Rolling Knolls Landfill Superfund SITE FIELD CHANGE REQUEST (FCR) FORM

Contract No.:		
REQUEST NO:	DATE:	06 07/ 10 06/2015
FCR TITLE:Existing Monitoring Well Analyses

GROUNDWATER ANALYTICAL RESULTS
GREATER THAN NEW JERSEY
GROUNDWATER QUALITY CRITERIA

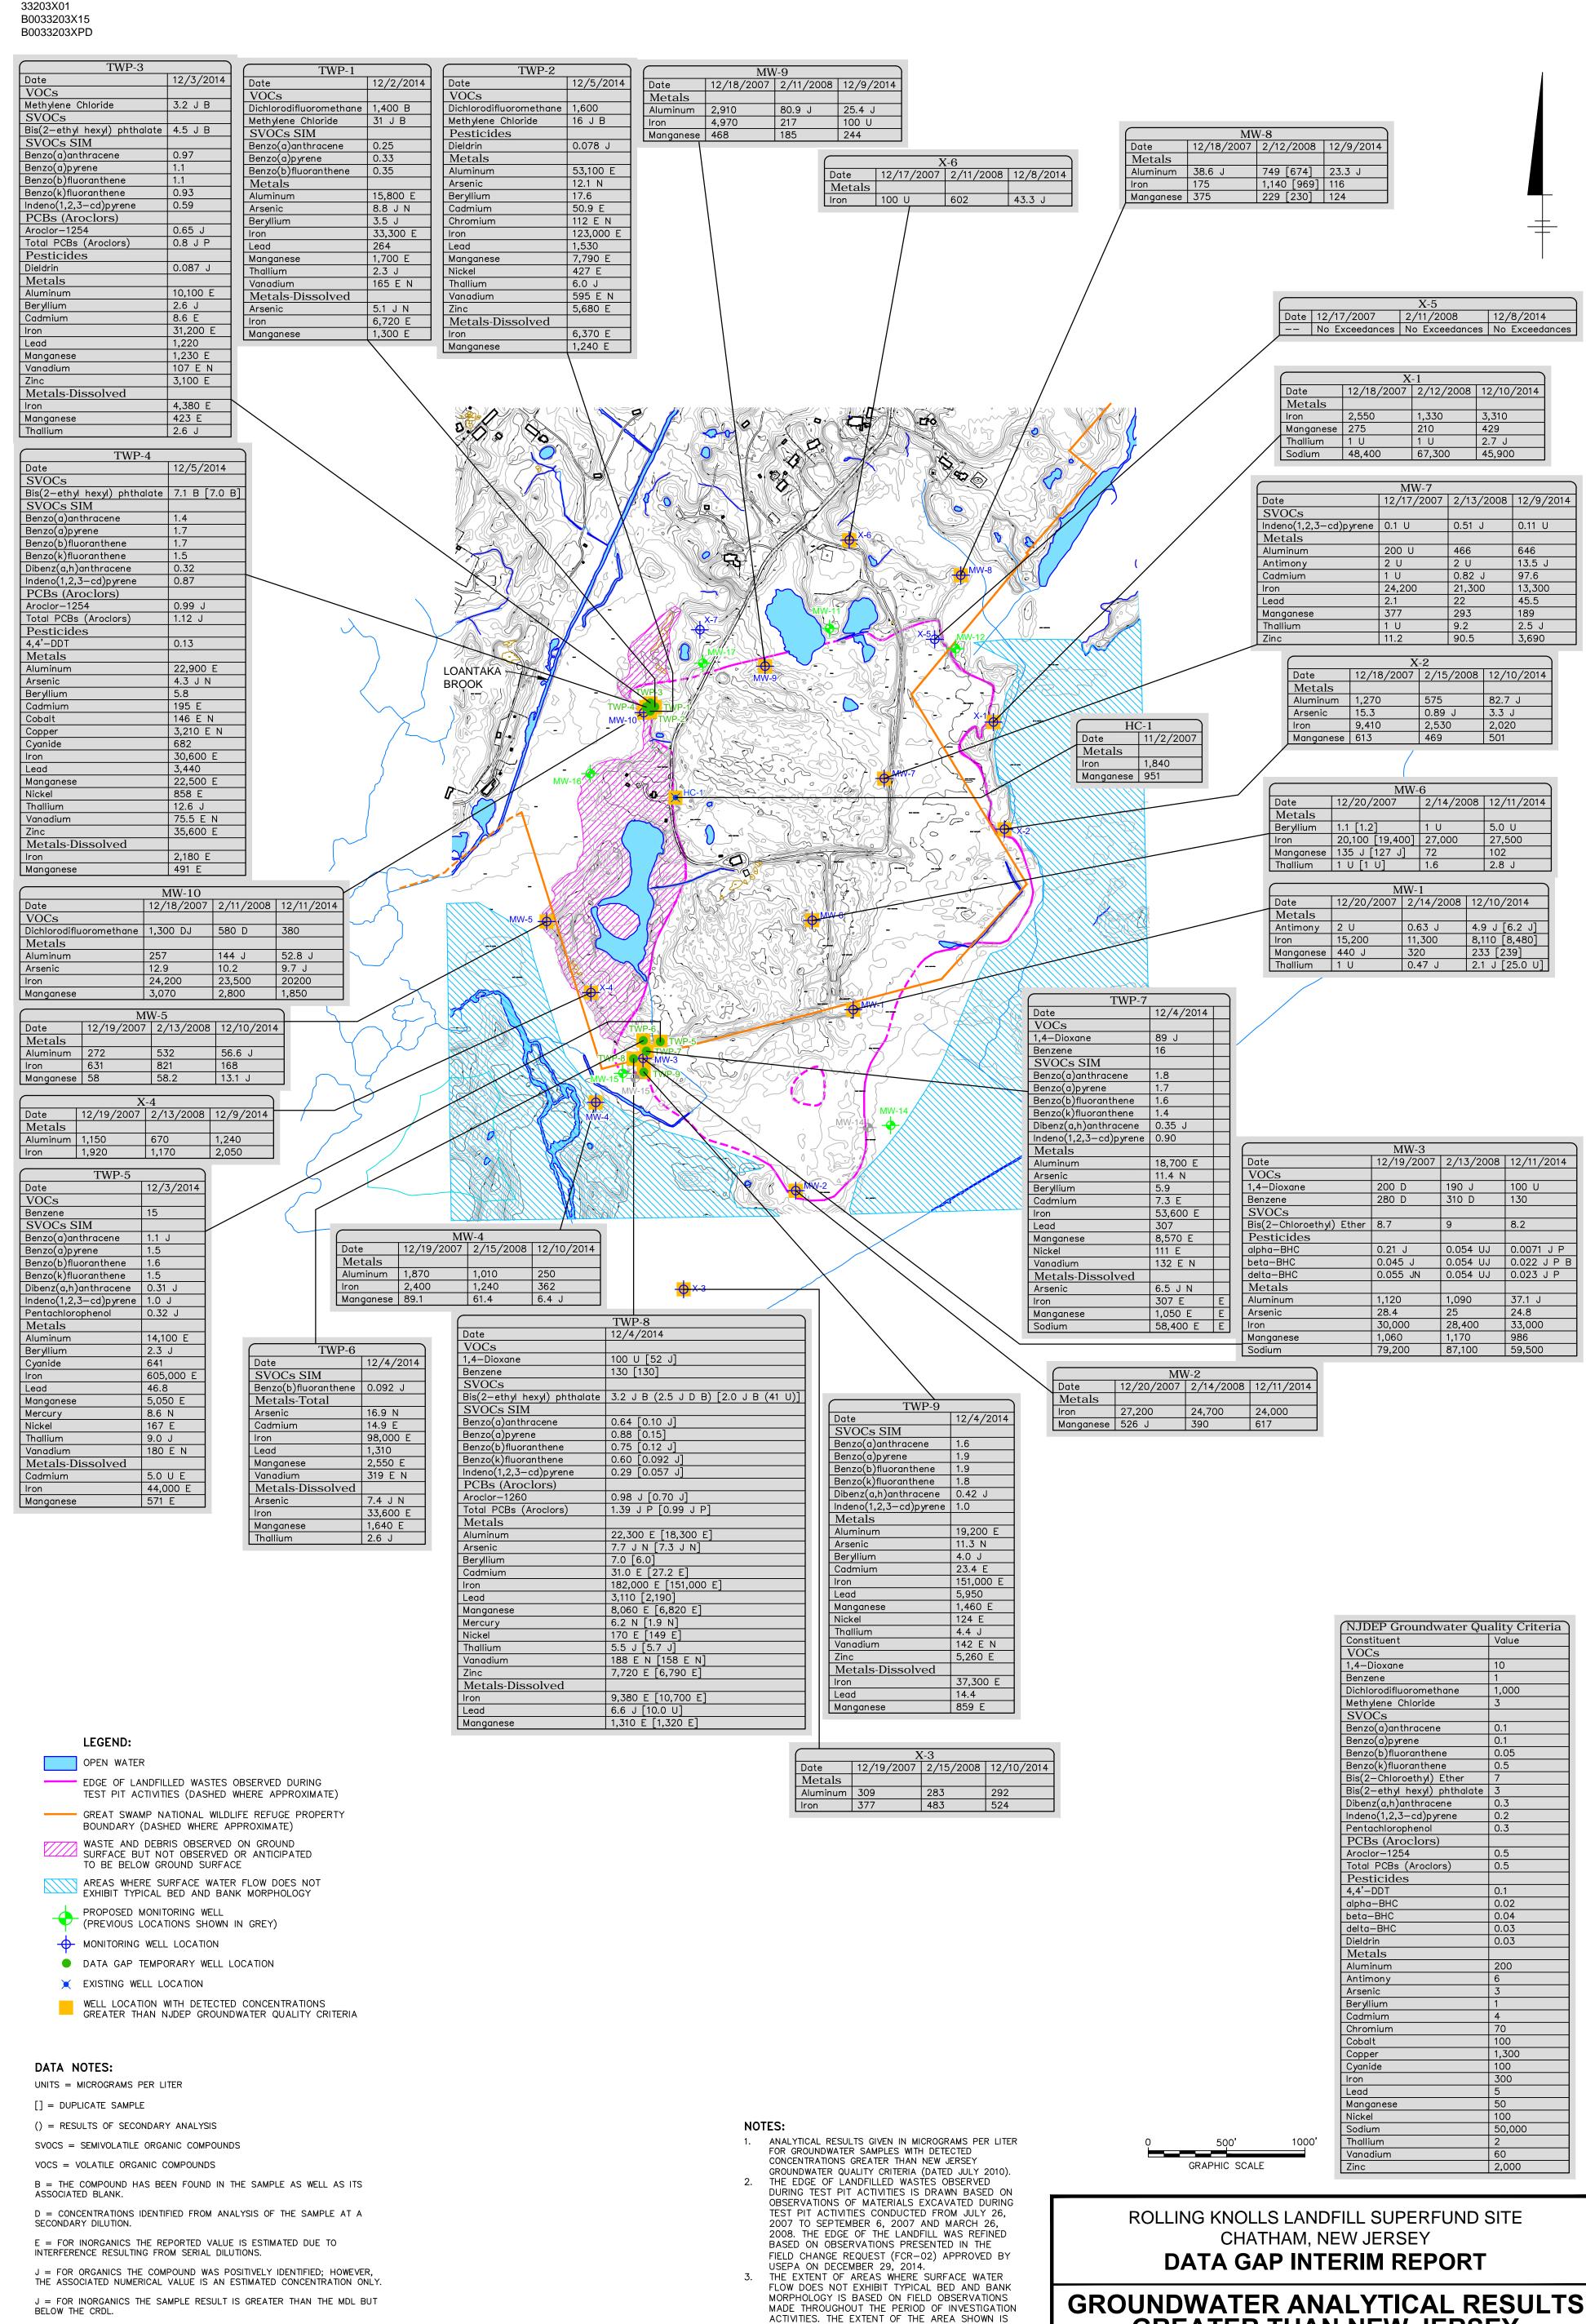
Groundwater sampling results from the three previous sampling events were presented in the Interim Tech Memo (submitted February 17, 2015). Figure 1 from the Interim Tech Memo is attached for reference. Monitoring wells MW-1 through MW-10 and X-1 through X-7MW-3 and MW-7 are selected for sampling during the second groundwater sampling event, and samples will be analyzed for full TCL/TAL.as described below:

- MW-3: Confirmation of VOCs and pesticides
- MW-7: Confirmation of metals (filtered and unfiltered) and cyanide
